MEMORANDUM

RE: Skybreak Subdivision - H-2020-0127

SUBJECT: H-2020-0127
Skybreak Subdivision

I. Proposed Private Street Sections (date: 6/16/21)

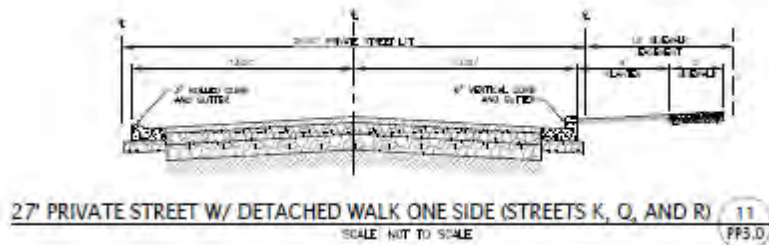
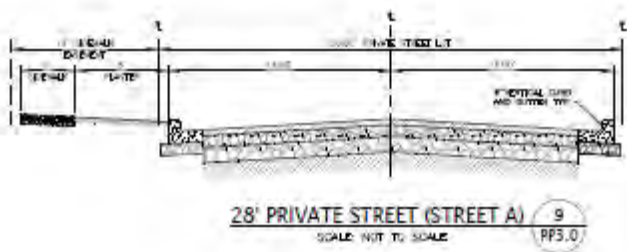
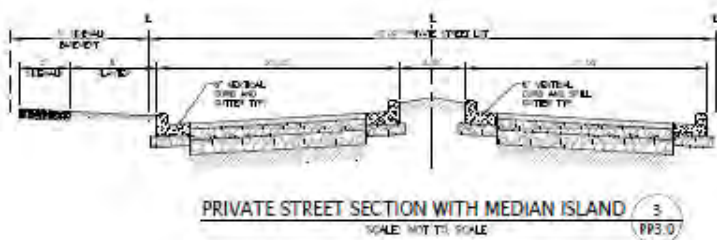
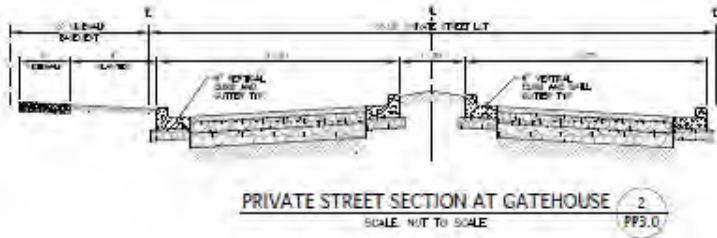
1. Provide sidewalks on at least one side of all streets;
2. Provide a better transition between the southern perimeter of the subdivision and the Vantage Pointe Subdivision to the south. This should be done by extending the larger lots at the southeast corner of Phase 7 to the west across the southern boundary to the Farr Lateral;
3. Relocate some of the open space at the south to a more central location.

The applicant has provided revised plans. The plans reflect street sections of the private streets to show a minimum 5' wide sidewalk on at least one side of the street. The private street and open space oriented east-west at the southern boundary of the property (adjacent to Vantage Pointe) has been replaced with lots meeting a minimum square footage of 20,900 sq. ft. (thereby extending larger lots along the southern boundary). The open space that was originally reflected at the southern boundary has been relocated to the center of the development (shown as 19,925 sq. ft. Lot 170, Block 5). The open space exhibit provided by the applicant reflects a slight reduction in what is being credited as qualifying open space from 14.99 acres to 14.5 acres. The total number of buildable lots has decreased from 329 lots to 316 (including the existing single-family residence). The 112 lots served by private streets has been reduced to 106. As requested by the Council, proposed conditions of approval have also been provided with this memorandum.
